Subject: RE: 163370

Principal Planning Officer

JOB TITLE	Stoney Court Poultry Units	CLIENT	Nr & SL Green
DRAWING TITLE	Proposed Site Access		
SCALE	1:1000@A3	DRAWN BY	NS
DATE	May 17	DRAWING No	18083-06-1
REVISION

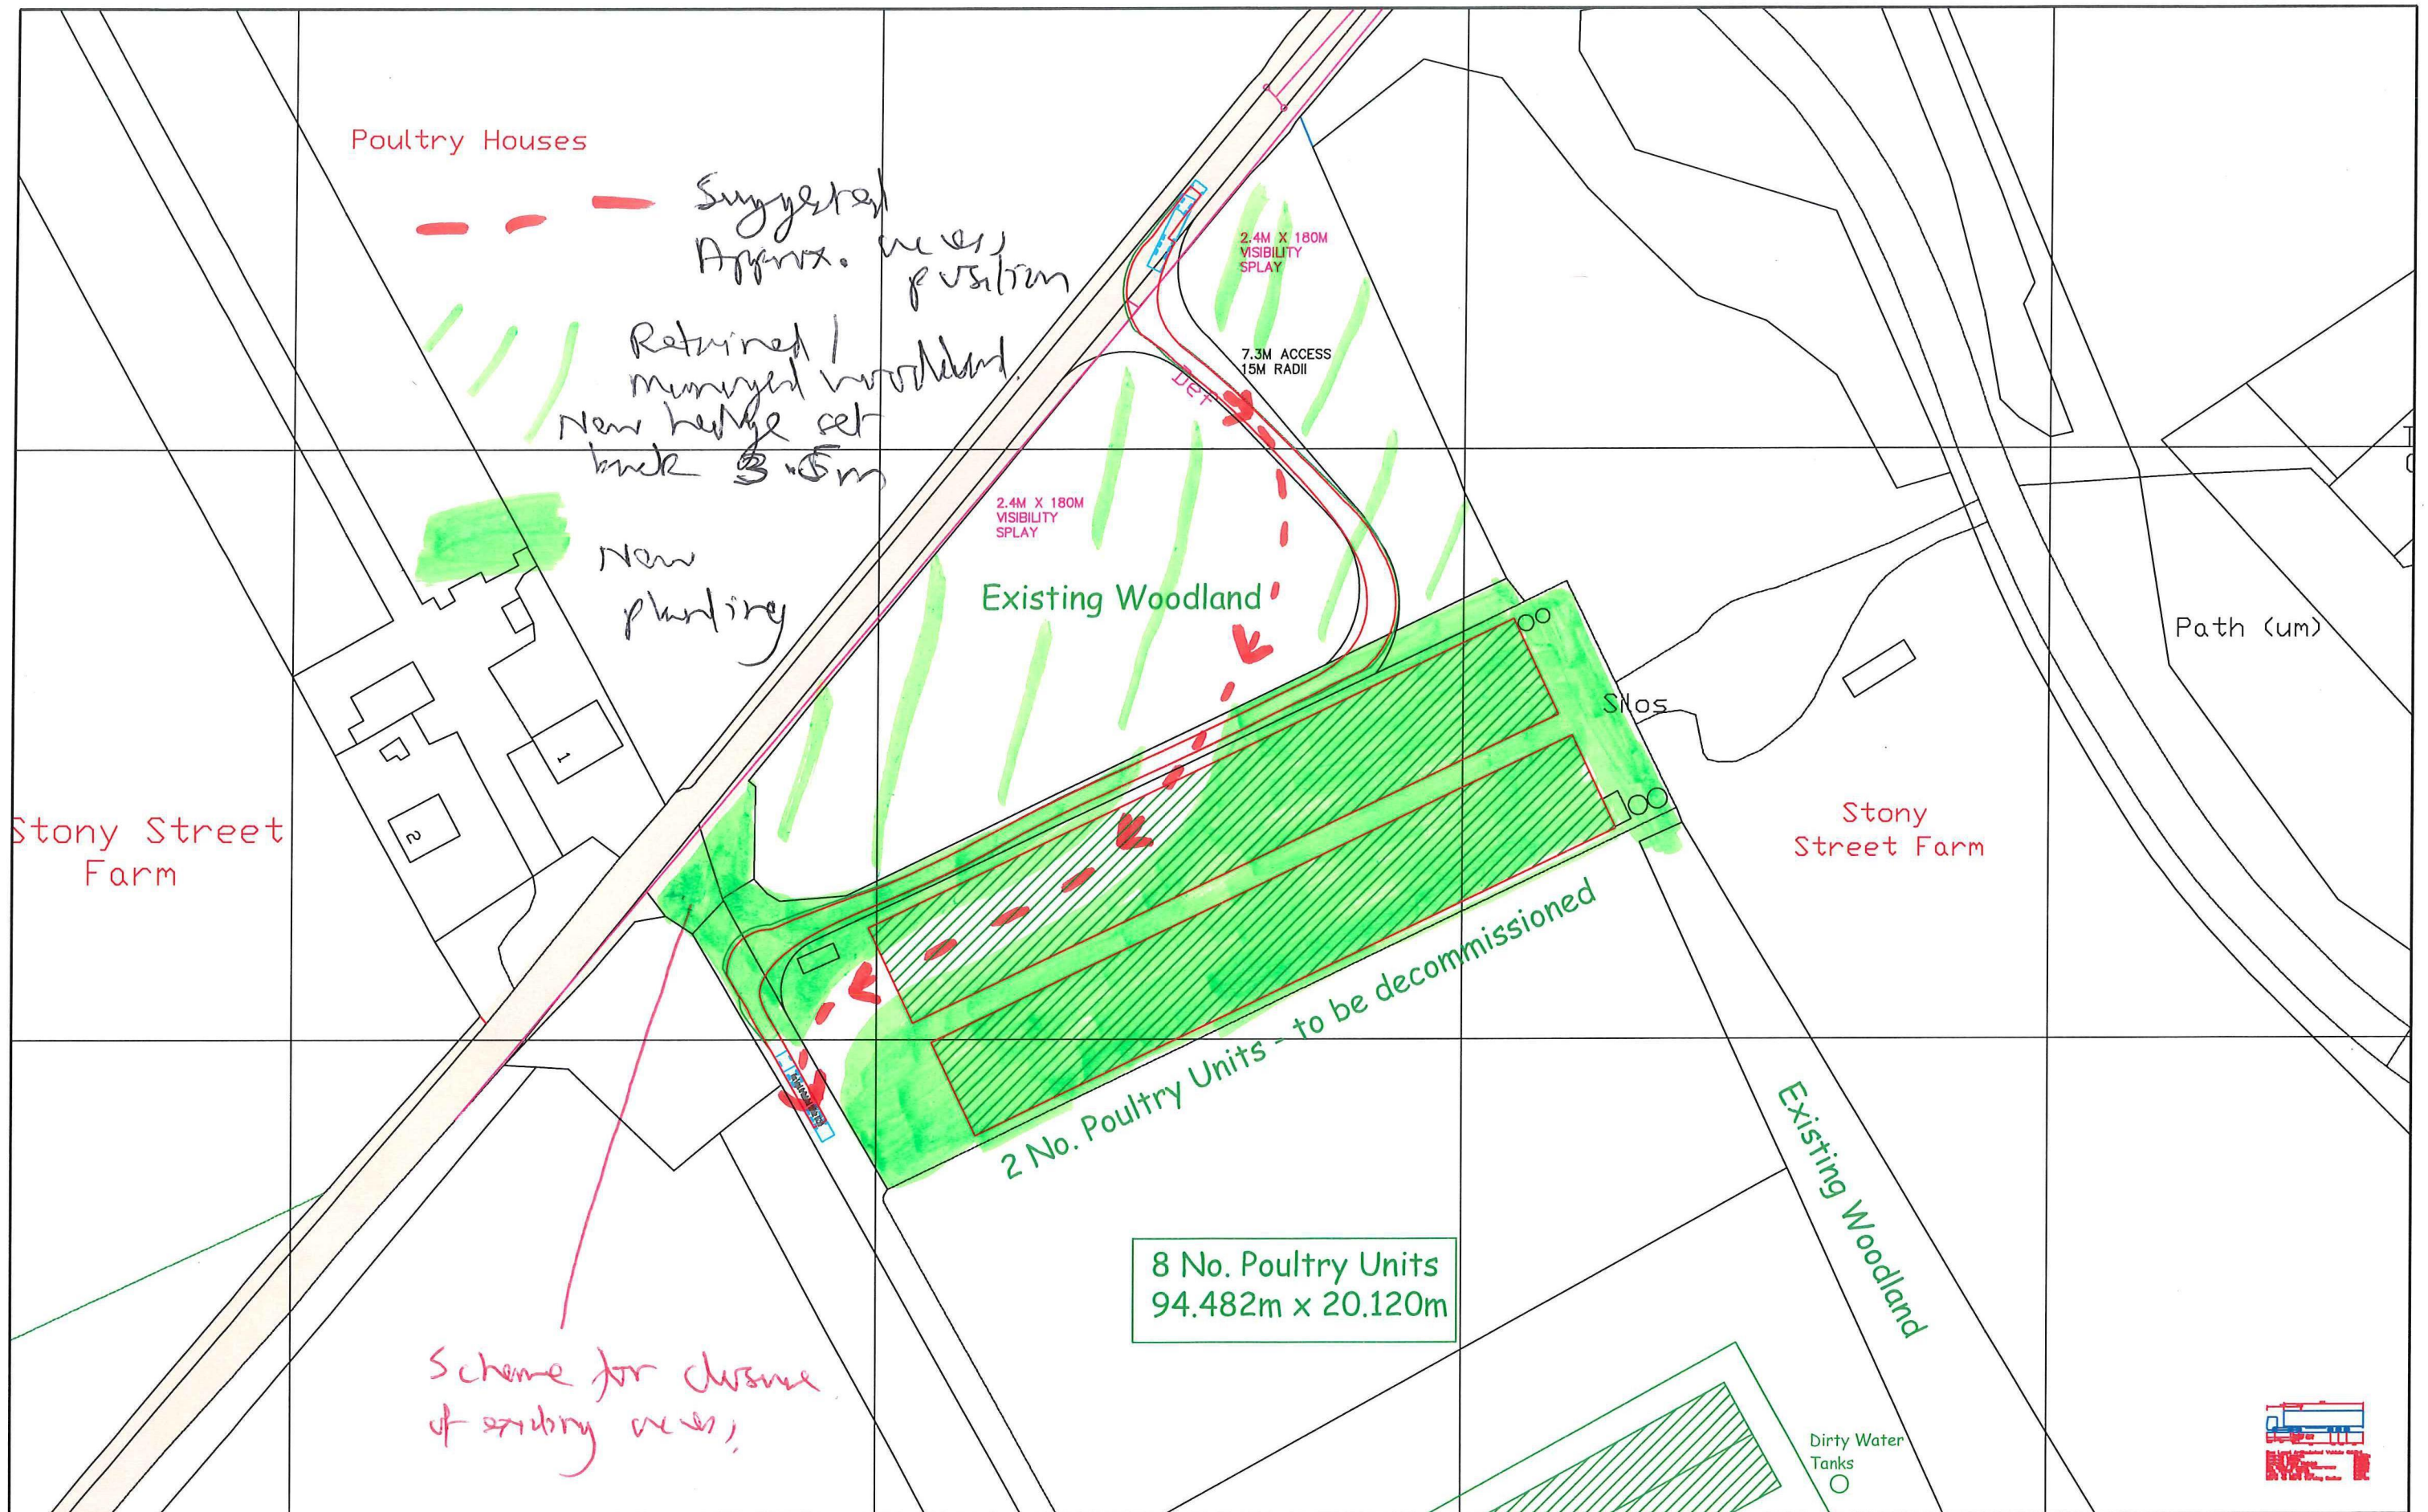
It does appear that the visibility splays may be achievable. However, I suggest that you not only establish the known highway extents but also:-

My Highways Officers advise me that there is also a section of hedgerow north of the BT bell mouth which would need to be maintained. Clearly again you would need to establish the precise land ownership situation.

I am also confused as to whether your proposal for a new vehicular access would also involve closure of the existing vehicular access. Clarification on this point is required. I would wish that access to be permanently closed, otherwise vehicles could utilise that access which would not have a visibility splay to the south secured.

Such a new vehicular access would involve a considerable amount of hedgerow and trees. It appears that the entirety of the hedgerow along the frontage which would need to be removed to achieve the requisite visibility splays of 2.4 m x 180 m.

The alignment of the road is of concern as it would allow a straight vista through. In my mind it would be preferable if the proposed access road swung round in a gentle curve to the south and followed the route of the poultry building(s) to be demolished. This would lessen the amount of woodland to be removed and make the access less visually intrusive. Clearly the precise alignment would need to be designed / tracked by your Highway Engineer but the above sketch attachment may help.

- a) compensatory planting should fill the gap of the decommissioned units providing further coverage and creating wildlife corridors;
- b) The revised line of the new access should be such so as to ensure NO impacts upon the existing southern edge of the woodland area – and should utilise the area currently covered by two of the existing units that are to be decommissioned so freeing up existing 'brownfield' area for use by the access road. A detailed construction environmental management plan that includes detailed ecological risk avoidance/method statements, tree protection zones and construction methods would be required;
- c) The roadside hedge that will be required to be removed to create the required visibility splay should be reinstated. We would suggest 3.5m setback for the hedge line to allow for the hedge to grow without the need to constantly maintain it;
